STAFF RECOMMENDATION

1209 Shelby Avenue
January 16, 2013

Application: Demolition—accessory structure; New construction – accessory building and Setback reduction

Figure 1. 1209 Shelby Avenue

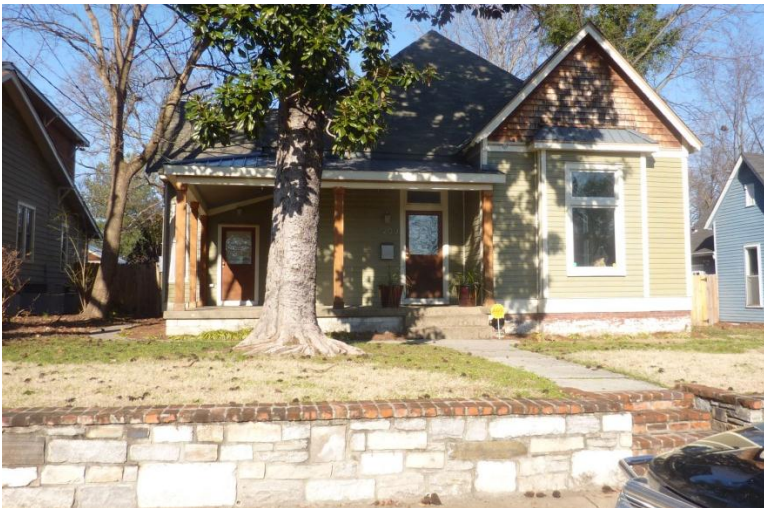
Background: 1209 Shelby Avenue is a transitional-Victorian house constructed c. 1910 (See Figure 1). It is considered to be a contributing structure to the Lockeland Springs-East End Neighborhood Conservation Zoning Overlay.

Figure 3. 1914 Sanborn Map shows an accessory structure on rear property line.

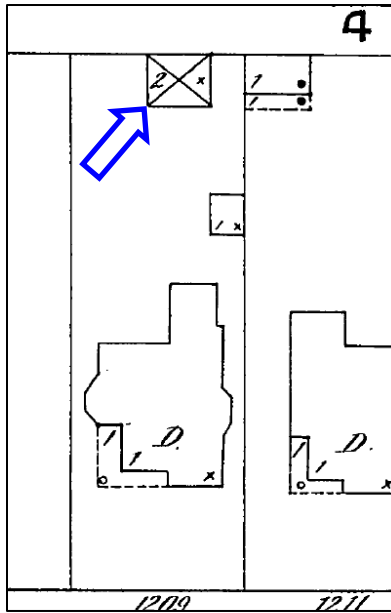
Staff finds the location of the garage and the setback reduction to be appropriate for several reasons. Historically, accessory structures were located close to the rear property line. In fact, the 1914 Sanborn map shows that there used to be an accessory structure on this site that abutted the property line (see Figure 3). In addition, staff finds that base zoning's required twenty-foot (20') rear setback does not match the historic context for the Lockeland-Springs district. Staff finds that a twelve-foot (12') setback is more historically appropriate for the neighborhood. Staff therefore finds that the location and setback for the proposed accessory structures meets Section II.B.3. and II.B.8. of the design guidelines.

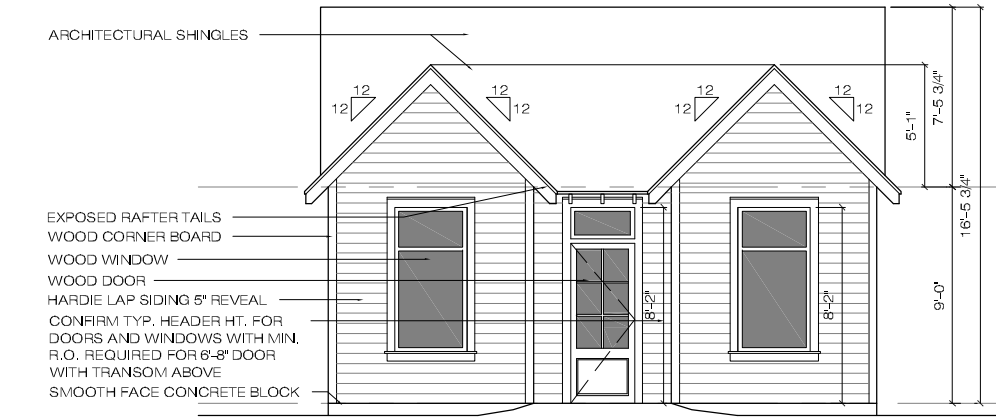
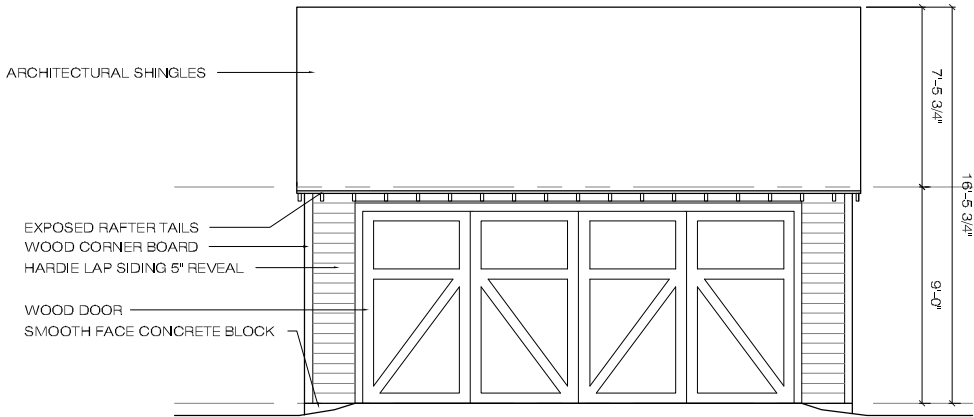
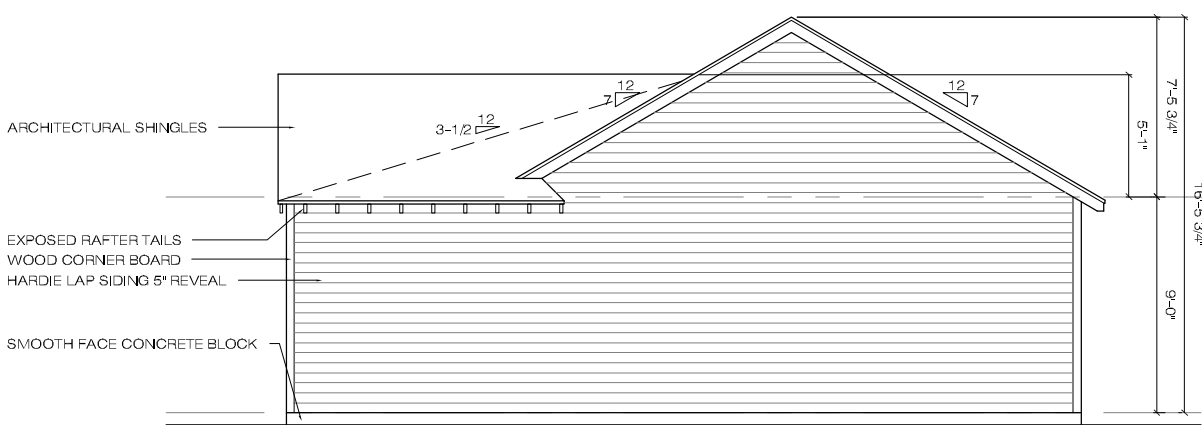
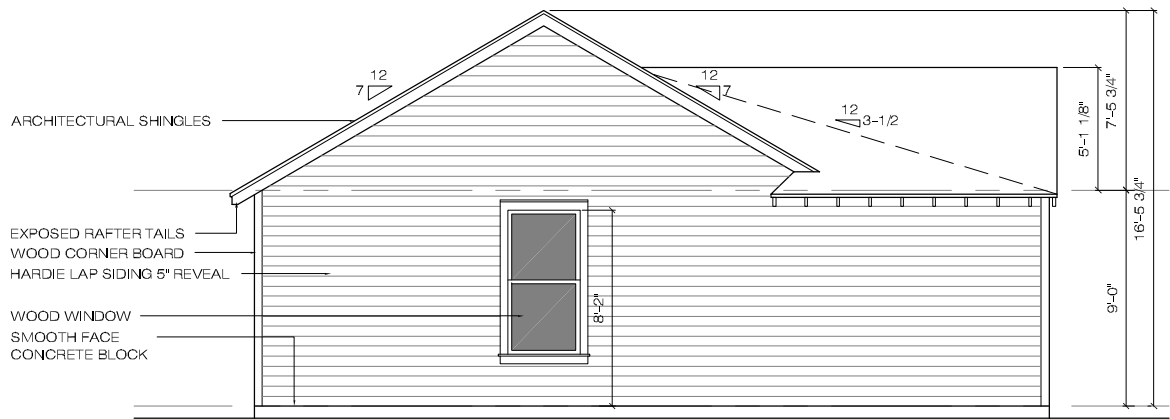
Height, Scale: The one-story accessory structure is proposed to have a ridge height of approximately sixteen feet, six inches (16'6") above the foundation, which is approximately six inches (6") tall. The eave height will be approximately nine feet (9') above the foundation. The structure's footprint will be approximately seven hundred and forty-one square feet (741 sq. ft.). By comparison, the primary structure has a foot print of approximately two thousand, one hundred square feet (2,100 sq. ft.) and a ridge height of approximately twenty-four feet (24'). Staff therefore finds that the accessory structure is subordinate in size and scale to the primary structure.

Materials: The proposed materials are smooth-faced cement-fiber siding with a five inch (5") exposure, smooth-face concrete block foundation that is only approximately six inches (6") tall, and an architectural shingle roof. If the shingle color does not match that of the house, staff asks to approve the color. The windows, doors, and exterior trim will be wood. Staff asks to approve the final specifications for all windows and doors prior to purchase and installation. Staff finds that the structure's materials meet Sections II.B.4. and II.B.8. of the design guidelines

Roof Form: The structure's primary roof form is a side gabled roof with a slope of 7/12. At the front of the structure are two projecting, gabled bays with roof slopes of 12/12.

Staff finds that the roof form is compatible with that of the house and with surrounding historic structures, and meets Sections II.B.5. and II.B.8. of the design guidelines.

Proportion and Rhythm of Openings: The structure will have two garage doors facing the alley, and one standard pedestrian door facing the interior of the lot. The structure's window openings are appropriate for an accessory structure. Staff finds that the accessory structure's proportion and rhythm of openings meets Section II.B.7. and II.B.8. of the design guidelines.

Staff recommends approval of the accessory building with reduced setbacks, with the condition that staff approve the final roof color and the final door and window specifications. With the final approval of the materials, staff finds that the accessory structure and reduced setbacks meet the applicable design guidelines for the Lockeland Springs-East End Neighborhood Conservation Zoning Overlay.

1 SITE PLAN
SCALE 1/32" = 1'-0"

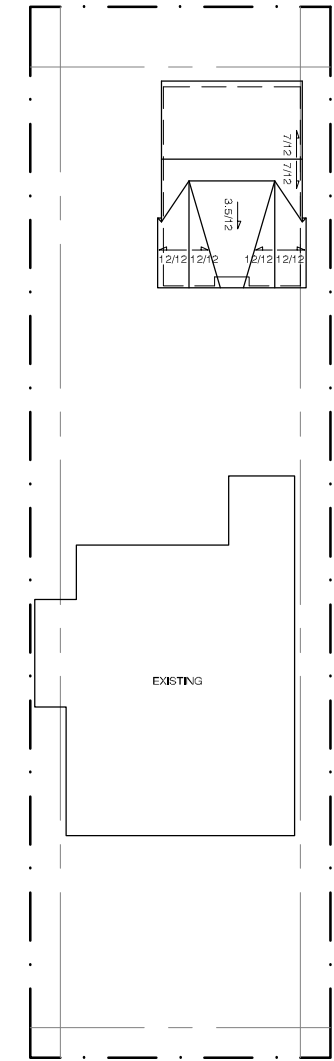
Location, Setback: The proposed accessory structure will be located entirely behind the existing house in the rear yard. The garage will be accessed via the alley, with garage doors facing the alley. The structure is proposed to be situated five feet (5') from the right property line and twelve feet (12') from the rear property line. Base zoning requires that an accessory structure that has a footprint greater than seven hundred square feet (700 sq. ft.) be located twenty feet (20') from the rear property line and five feet (5') from the side property lines. The project therefore requires a setback reduction.
